Re: Minor Project Refinement No. 6 for the TL 6975 San Marcos to Escondido Project.

TL6975 San Marcos to Escondido 69 kV Project CPUC Minor Project Refinement Form

ATTACHMENT B
MPR-6 Figure

MPR-6 Figure 1
Structure Location 78
San Diego County, CA

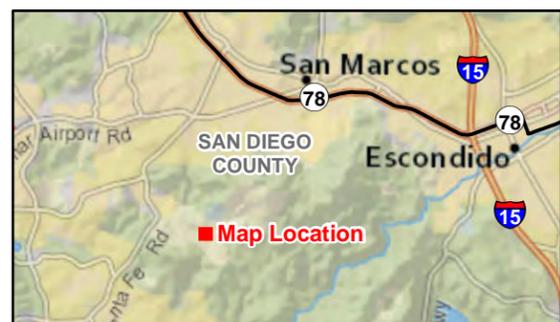
A regulator station was installed in the location where Location 78 was originally approved in mid-2020, which resulted in the reconfiguration of the overhead alignment and the relocation of Location 78. Grading will be required to create a level construction work area and permanent work pad for the new position of Location 78.

Location 78 must be installed and the associated overhead distribution line must be reconfigured before the Segment 3 reconductoring can occur between Locations 70 and 85. This makes Location 78 a critical component of Segment 3 activities.

It should be noted, the total size of the permanent disturbance area associated with Location 78 is 6,023 square feet (0.14 acre); however, the permanent work area for the original Location 78 (1,273 sf or 0.03 acre) was deducted as to not double-count overlapping impacts. Therefore, the proposed MPR-6 permanent work area would result in a new permanent impact of 4,750 square feet (0.11 acre). The temporary impacts proposed in MPR-6 do not overlap with the original temporary impacts for Location 78.

MPR-6 PHOTO LOG

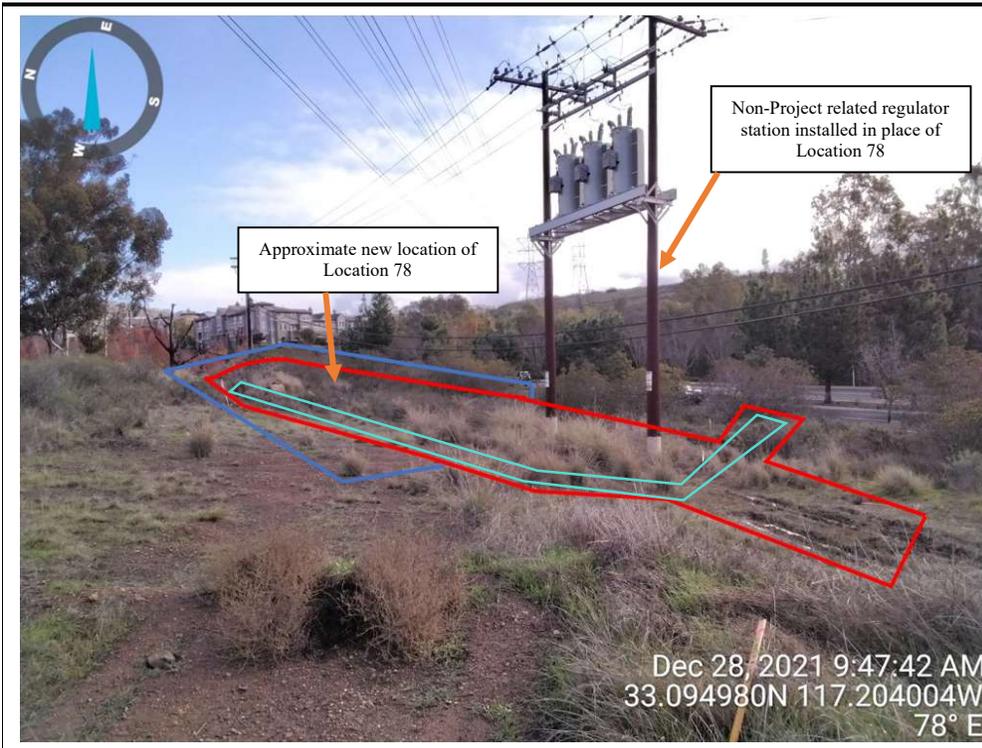
Photograph 1:
View of the MPR-6 temporary work area in dark blue, permanent work area in red and the approximate location of the brow ditch feature in teal. Facing: E

Photograph 2:
View of the MPR-6 temporary work area in dark blue, permanent work area in red and the approximate location of the brow ditch feature in teal. Facing: NE
